Final Environmental Impact Report Comments and Responses

For the San Francisco Public Utilities Commission's LOWER CRYSTAL SPRINGS DAM IMPROVEMENTS PROJECT

San Francisco Planning Department Case No. 2006.0536E
State Clearinghouse No. 2007012002

DATE: September 22, 2010
TO: Members of the Planning Commission and Interested Parties
FROM: Bill Wycko, Environmental Review Officer
RE: Comments and Responses on Draft Environmental Impact Report for Case No. 2006.0536E, Lower Crystal Springs Dam Improvements Project

SFPUC Lower Crystal Springs Dam Improvements
Figure 5.1-3 (Revised)
 Overlapping Construction Zones for
 Cumulative Projects in LCSD Vicinity

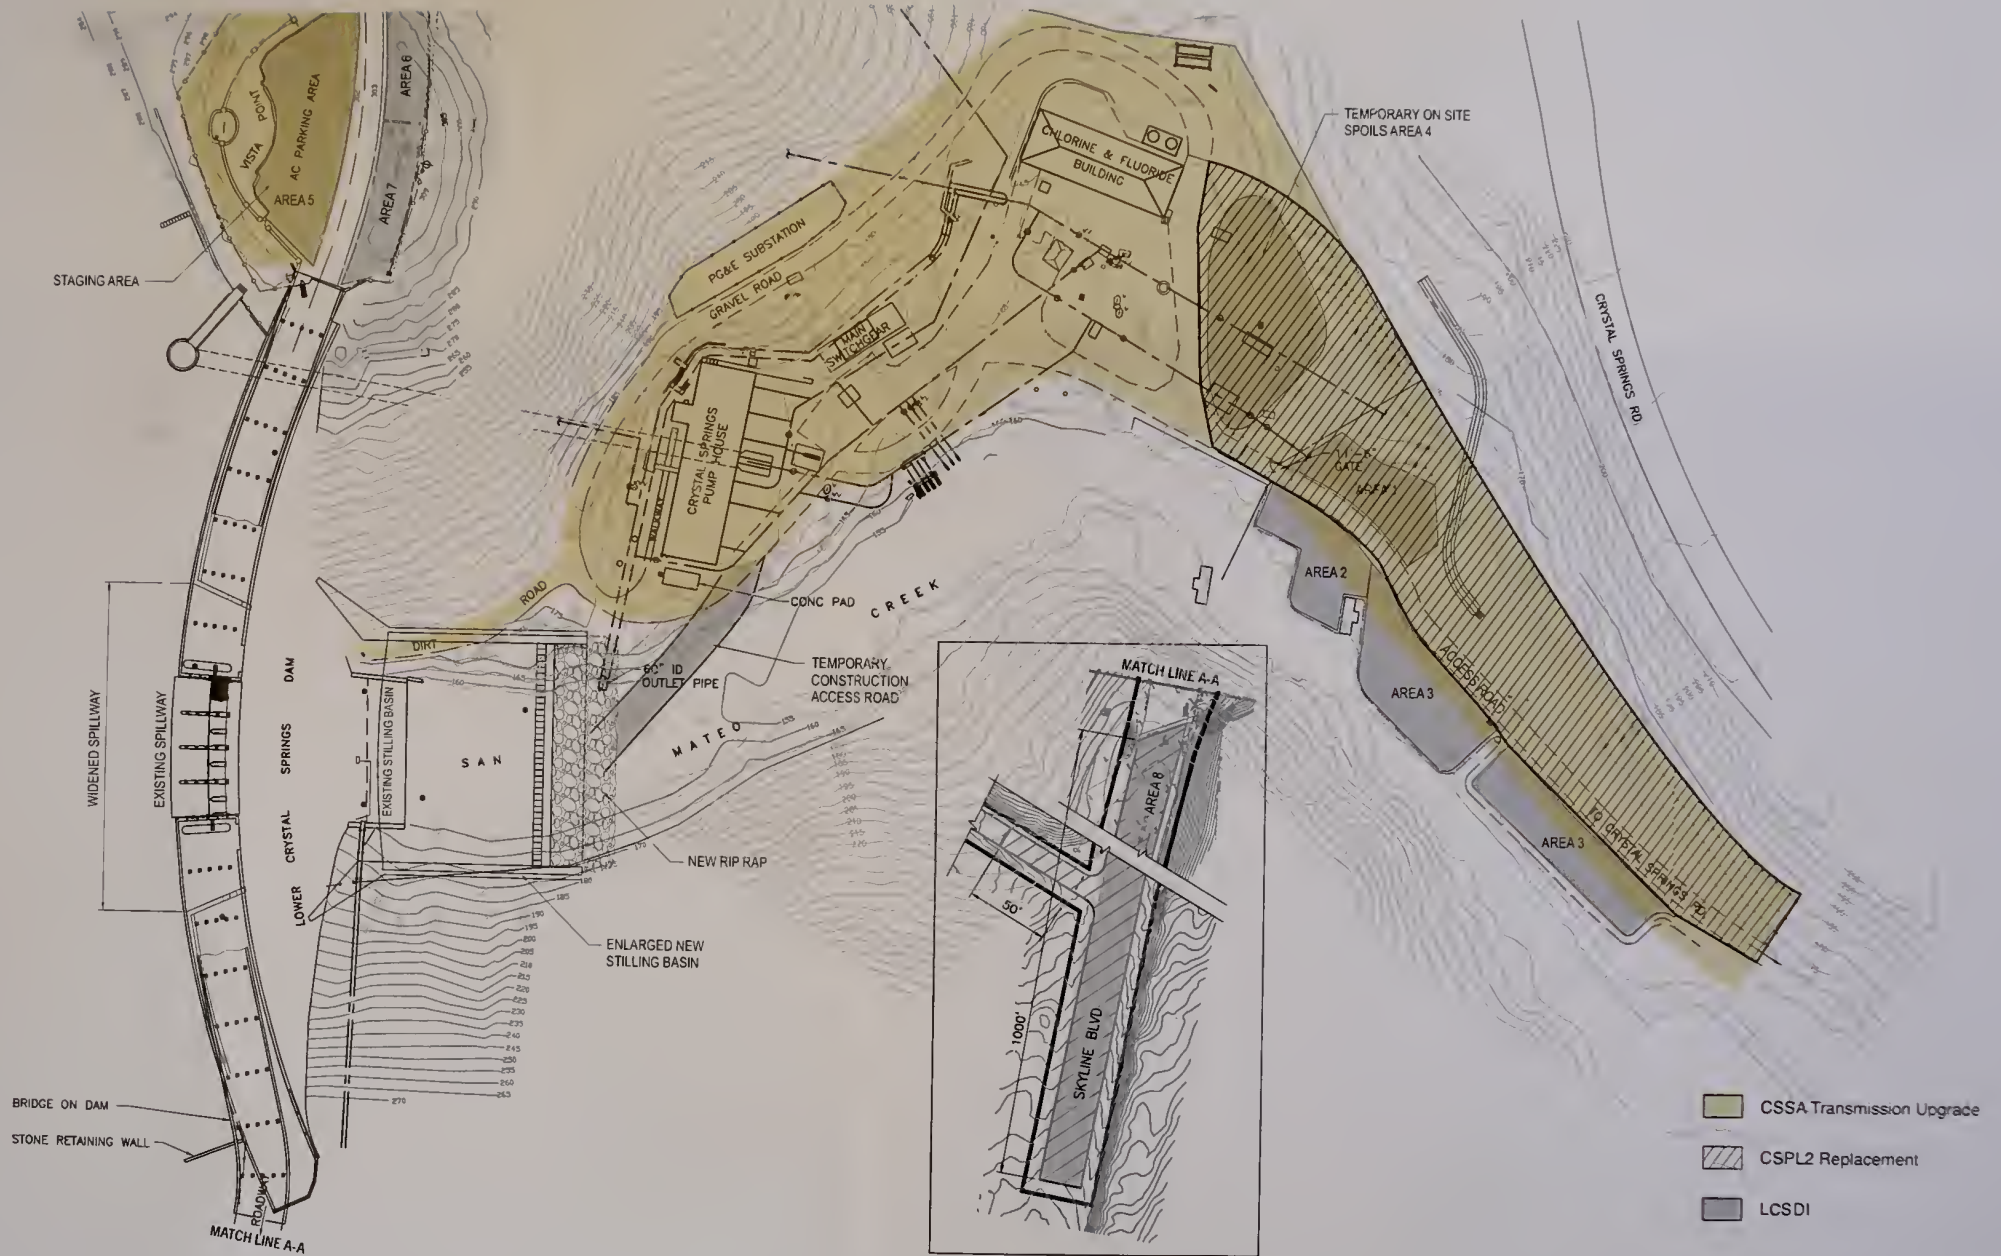
The contour lines for San Mateo Creek should be included in Figure 5.1-3 so project boundaries which overlap San Mateo Creek are clear." (*Charles Armor, California Department of Fish and Game – Bay Delta Region [A_CDFG-05]*)

The contour lines for San Mateo Creek should be included in Figure 5.1-3 so project boundaries which overlap San Mateo Creek are clear.

On Draft EIR page 5.1-13 (Vol. 1, Chapter 5, Section 5.1.4), Figure 5.1-3 (Overlapping Construction Zones for Cumulative Projects in LCSD Vicinity) presents similar information and uses the same base map as shown on Draft EIR page 3-21 (Vol. 1, Chapter 3, Section 3.6.2), Figure 3-8 (Staging and Storage Areas in the Lower Crystal Springs Dam Vicinity). In response to this comment, both figures are revised to include contour lines along the San Mateo Creek channel below the dam. The revised figures are presented in Chapter 5, Draft EIR Revisions, of this Comments and Responses document.

Figure 5.1-3 on page 5.1-13, Section 5.1.4: This figure is revised to include contour lines along the San Mateo Creek channel below the dam in response to Comment PD6.

SFPUC Lower Crystal Springs Dam Improvements
Figure 3-8 (Revised)
Staging and Storage Areas in the
Lower Crystal Springs Dam Vicinity

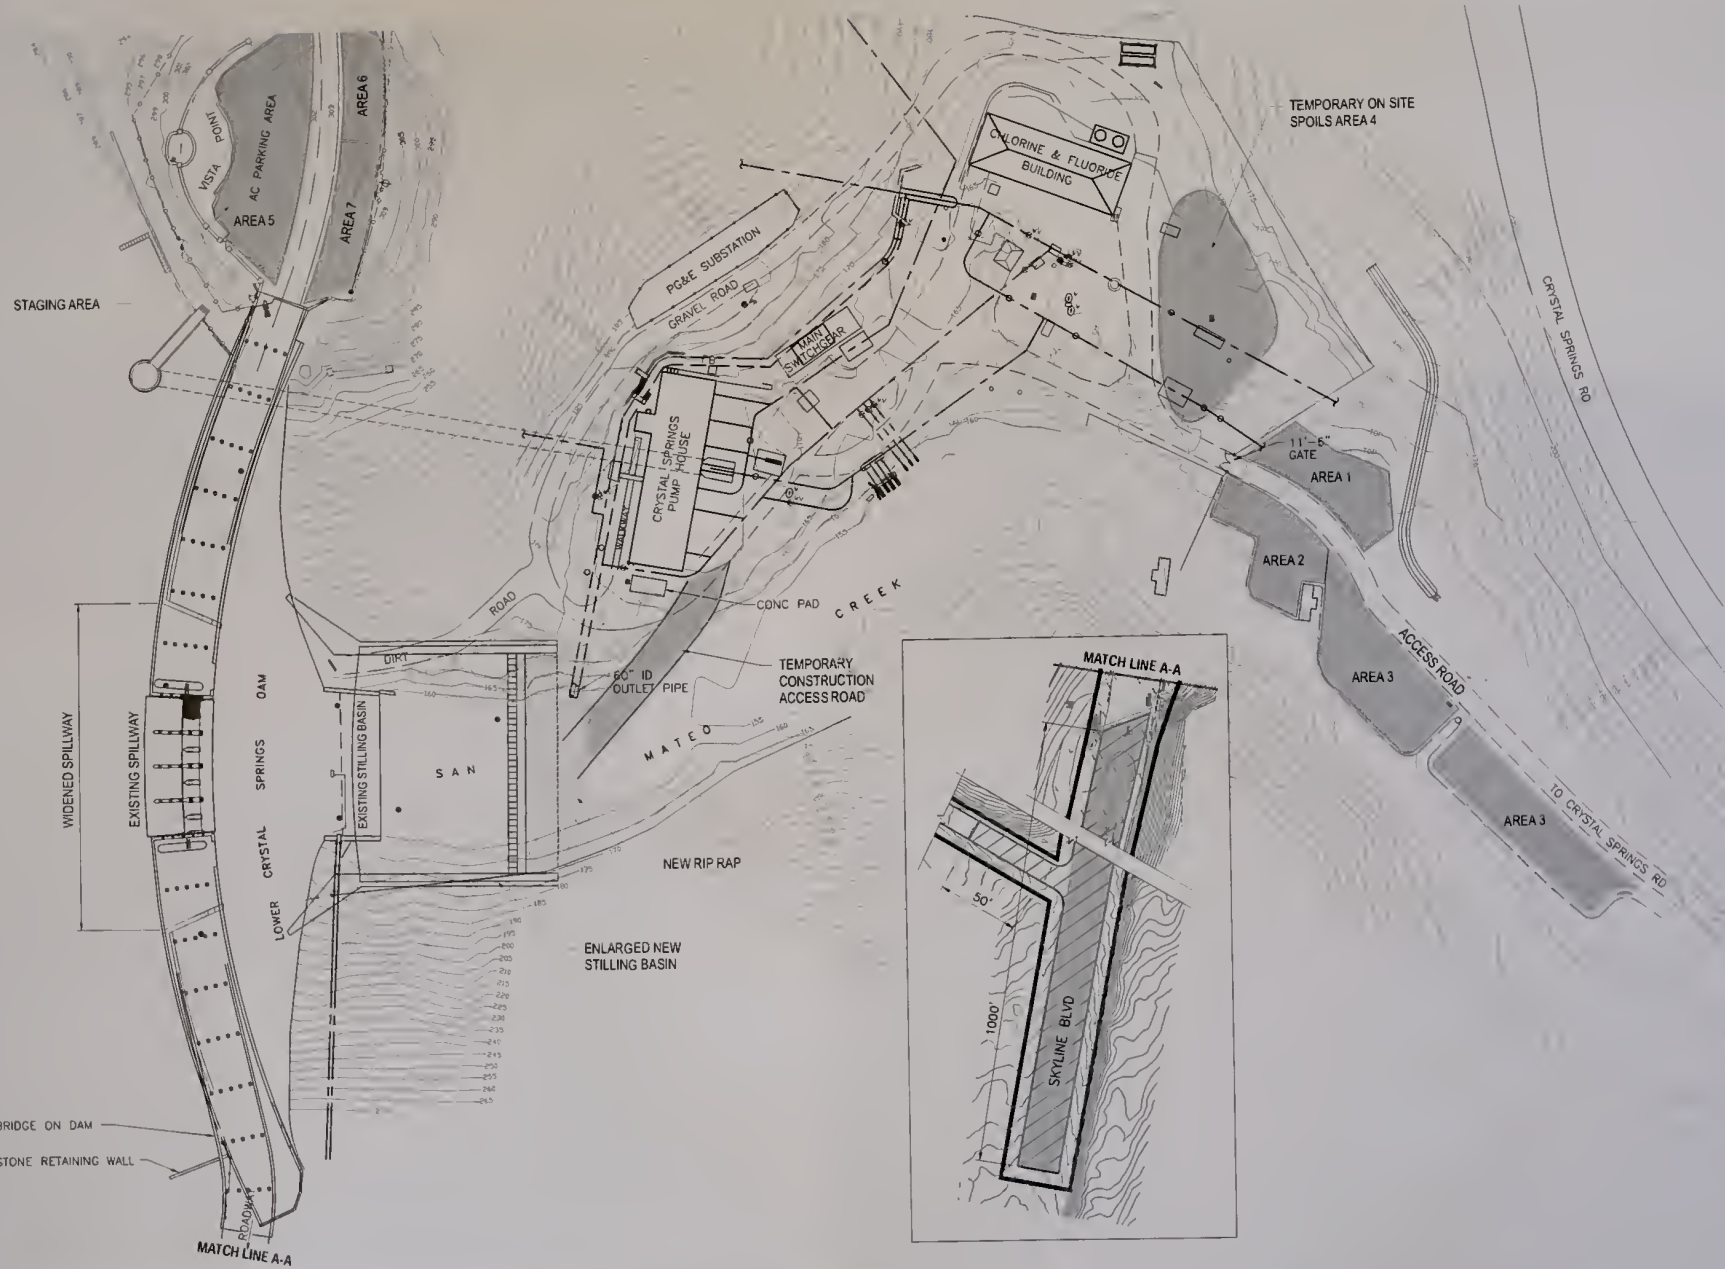
Figure 3-8 on page 3-21, Section 3.6.2: This figure is revised to include contour lines along the San Mateo Creek channel below the dam in response to Comment PD6.

SFPUC Lower Crystal Springs Dam Improvements
Figure 5.3-11 (Revised)
 Visual Effects of Inundation on Shoreline
 Vegetation from Skyline Boulevard

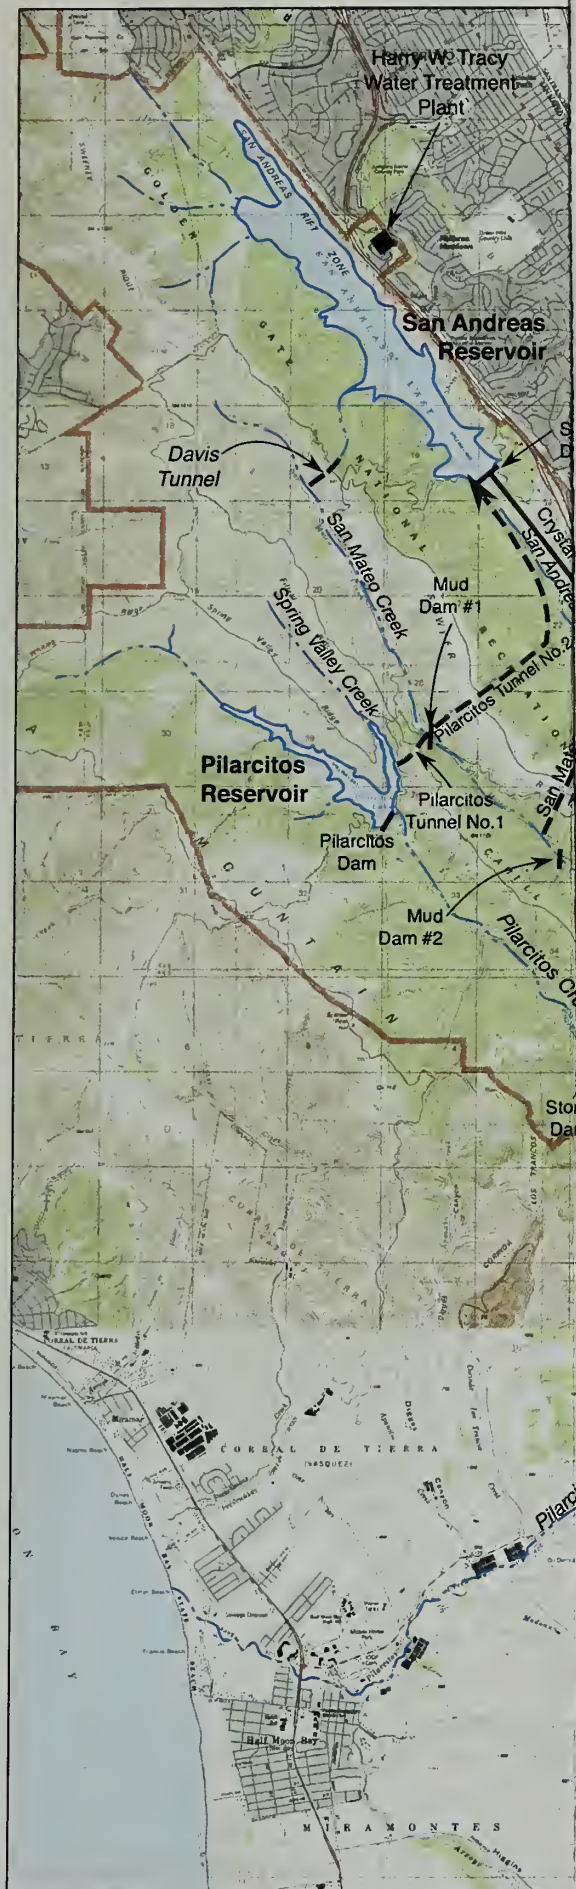
Figure 5.3-11 on page 5.3-31, Section 5.3.3: The text below the first photograph is revised to omit the word ‘possible’ from ‘possible mitigation site’.
